PLANNING COMMISSION

**Planning Commission Agenda
Regular Meeting
Virtual Meeting via GoToMeeting*
Thursday, December 10, 2020
6:00 P.M.**

- b. **P2020-026: Lupton Village Change of Zone**
- c. **P2020-027: Lupton Village Preliminary Plat & Preliminary PUD Plan**

SHEET
C6.2

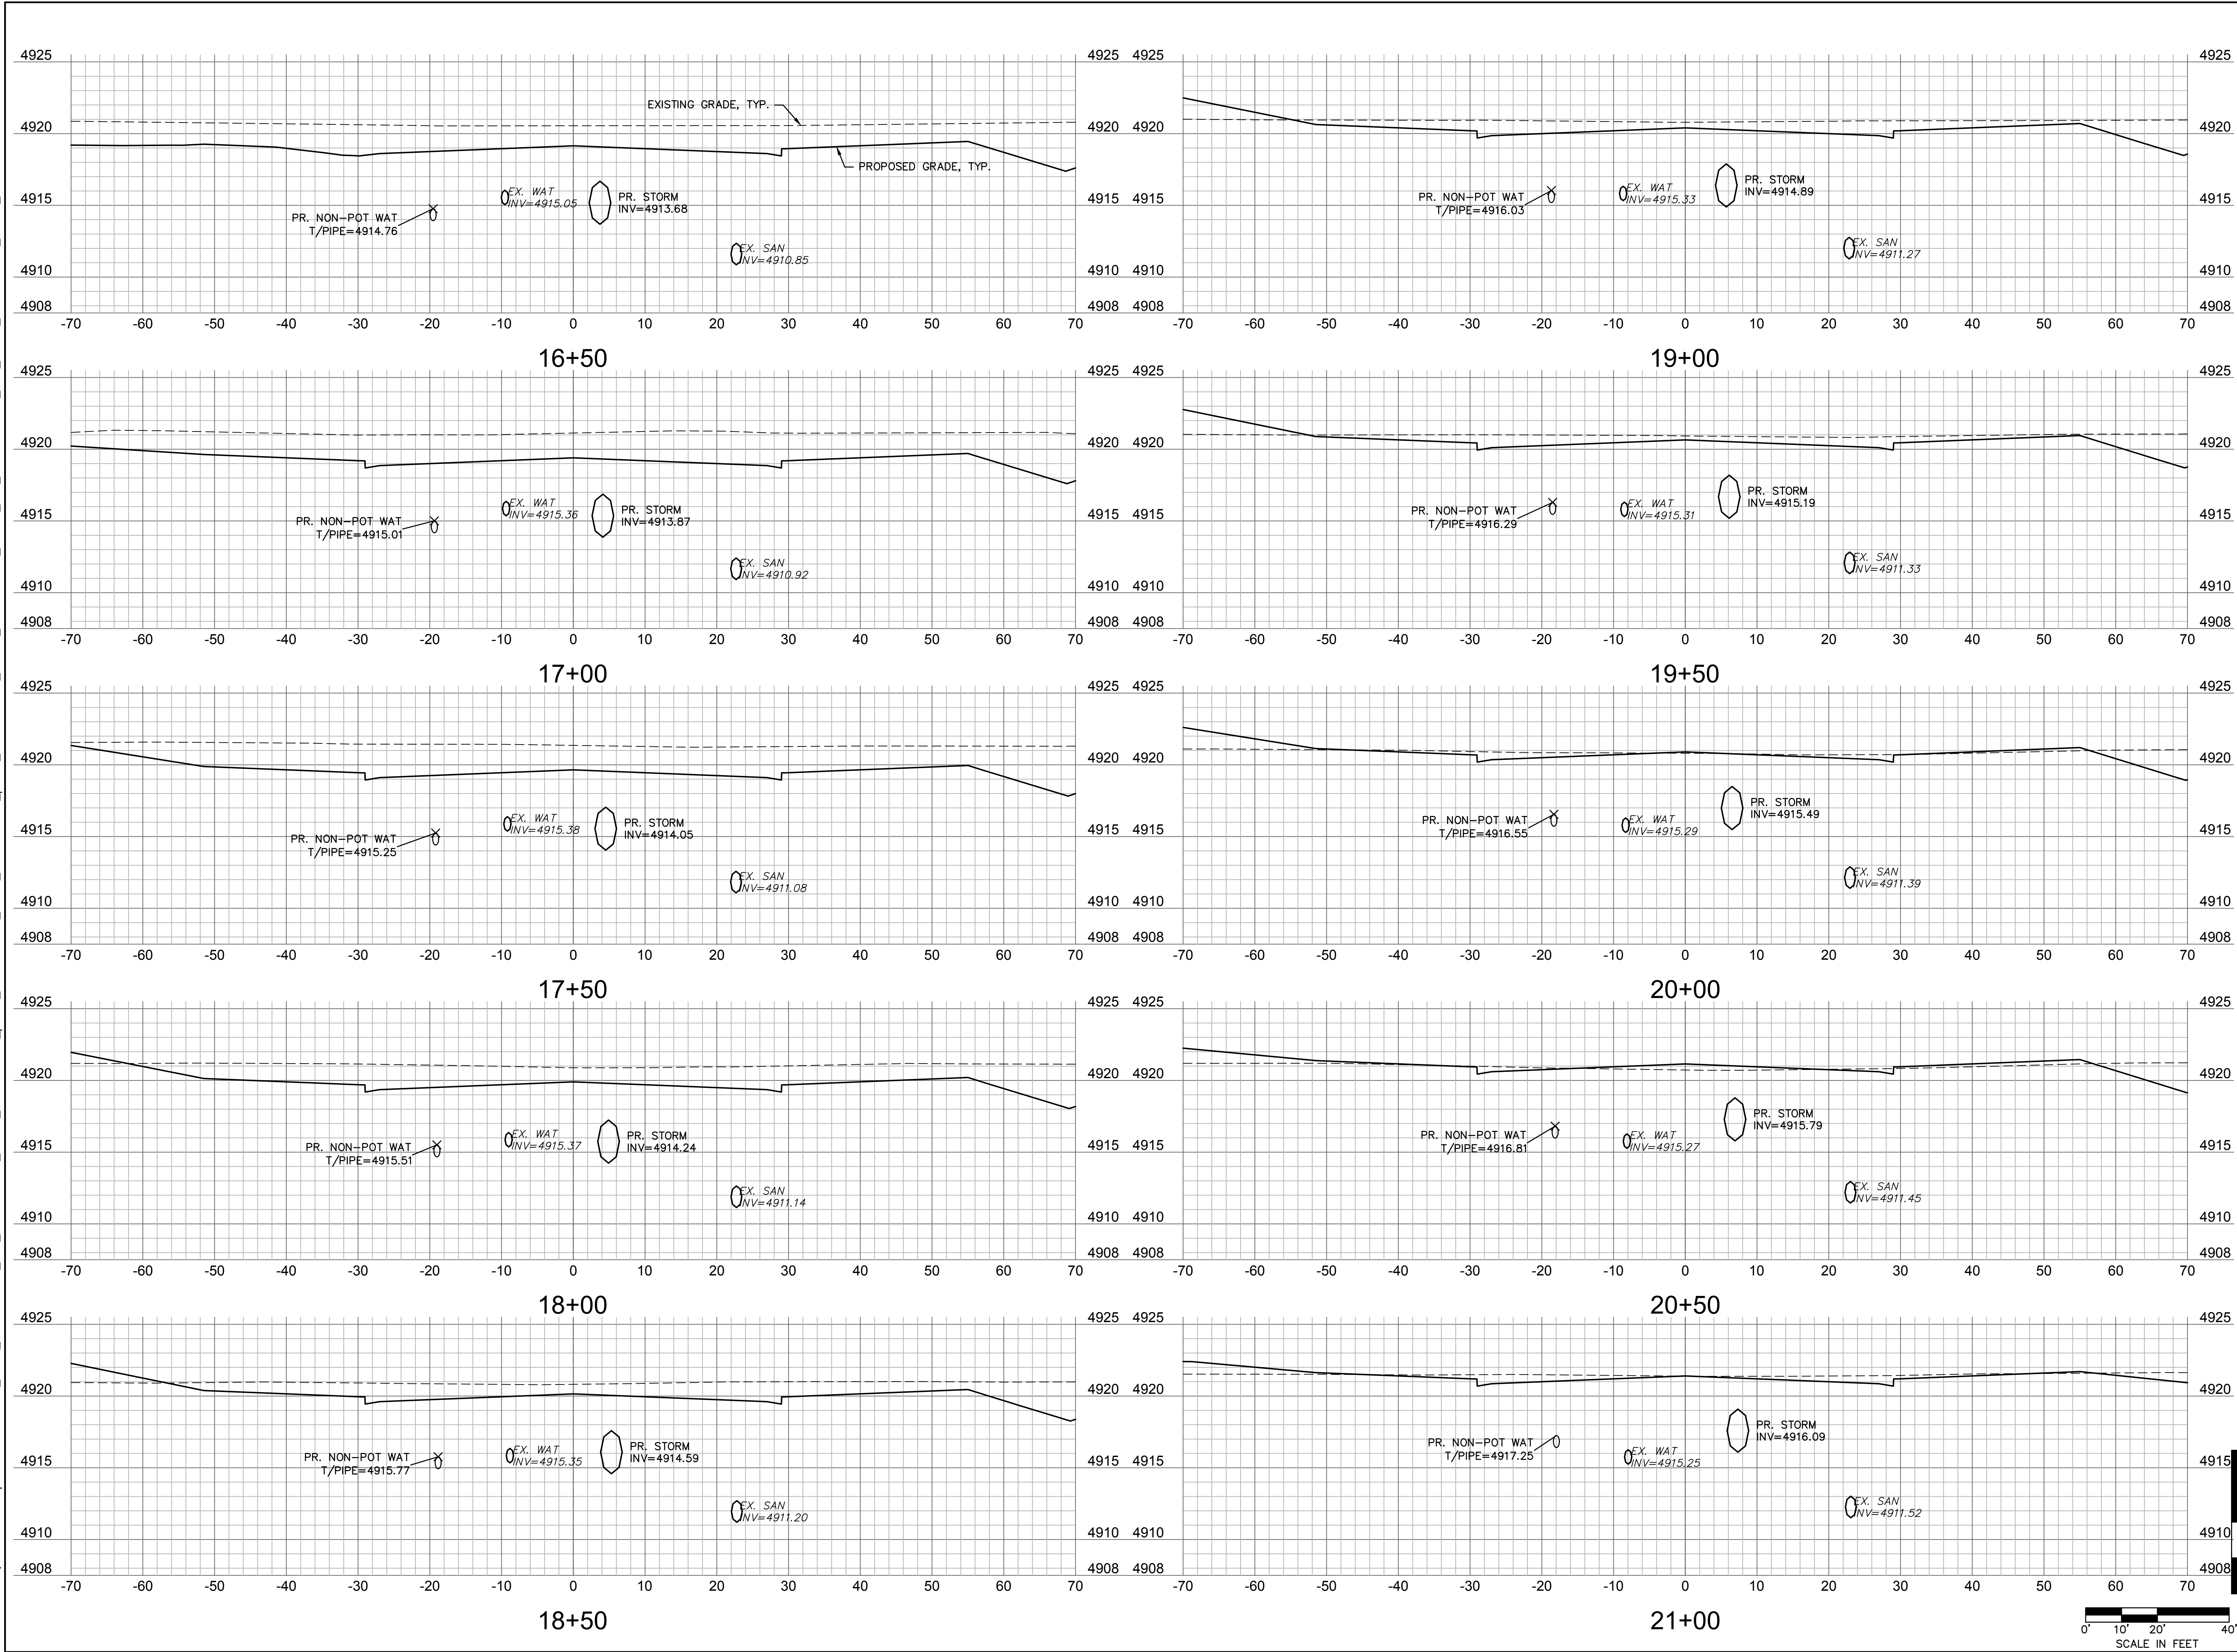
- c. Sheet C6.2 - CR 12 section looks off. Future widening of CR12 would include completing the 2nd lane. Please shade in ultimate section for CR 12 and stop the curb returns at crossing.

SHEET
C8.0

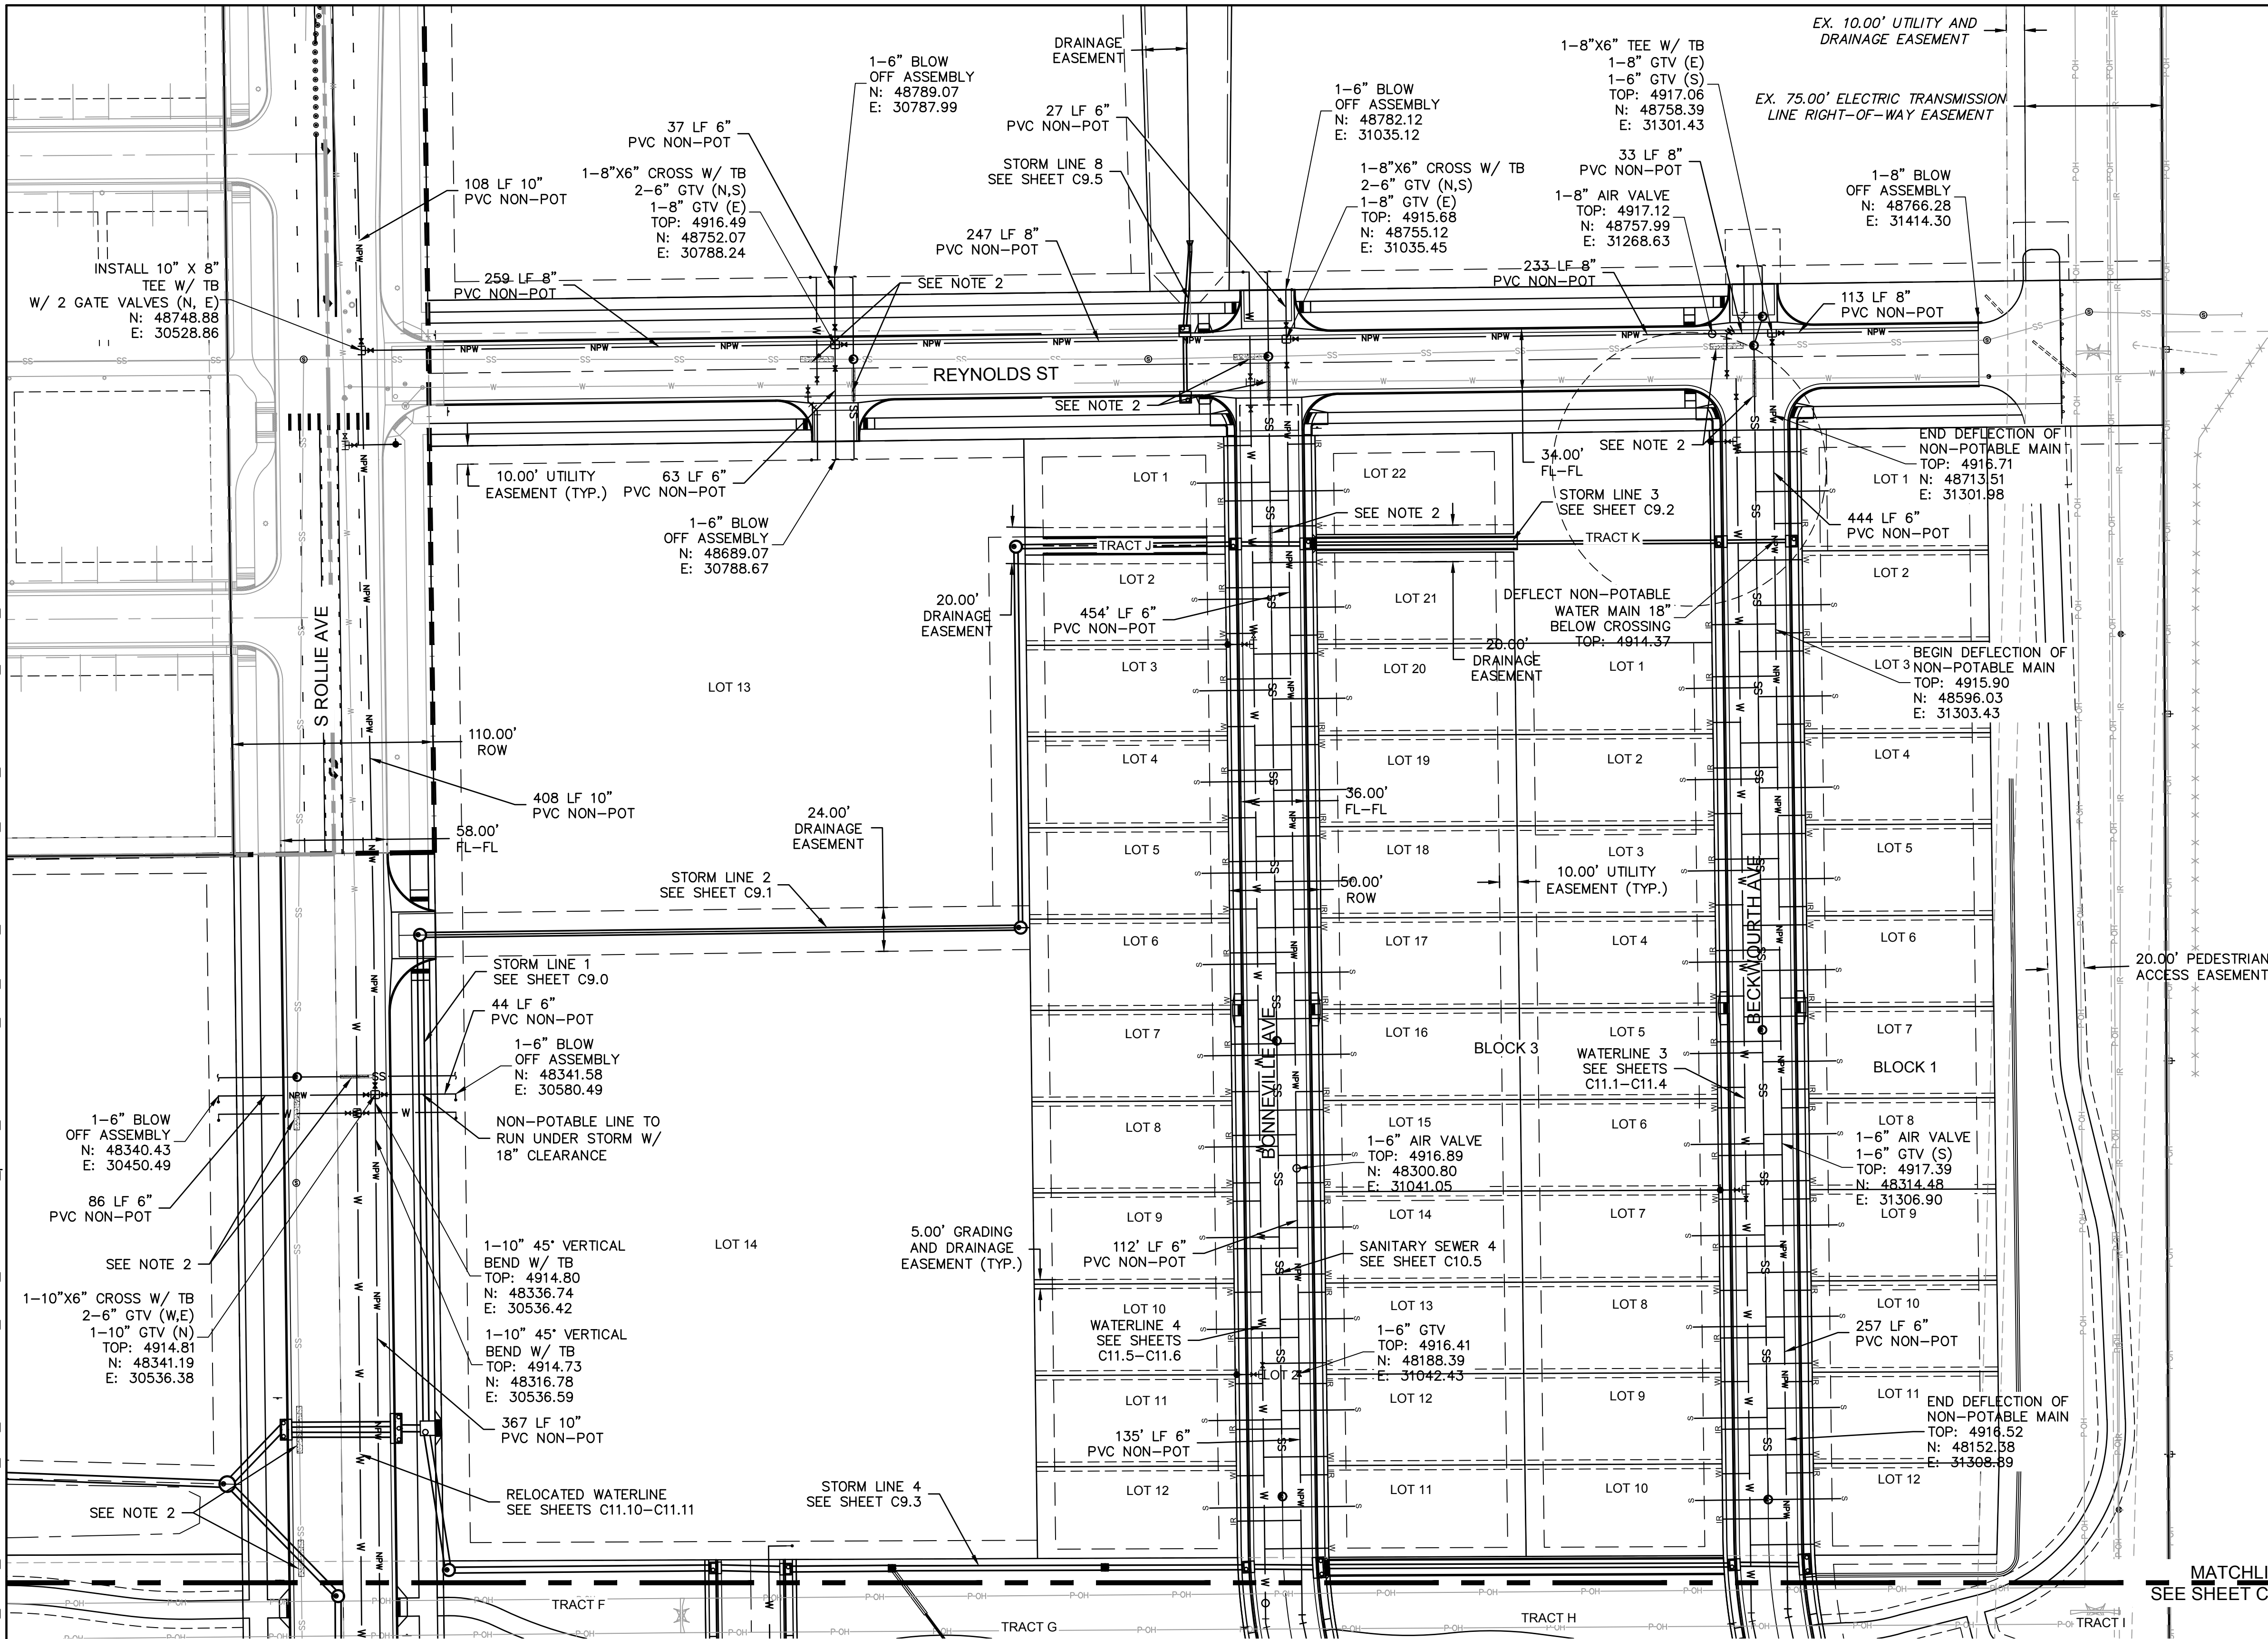
- e. Sheet C8.0 - .03 - Note #9. Change to purple PEX instead of copper.
- f. Sheet C8.2 - locate meter vault in the open space area
- g. Sheet C9.5 - Stm6 &7 - Revised IAW 6.c.i comment above. Add for flows from west. The proposed changes to the existing storm sewer are not covered (and shouldn't be required).
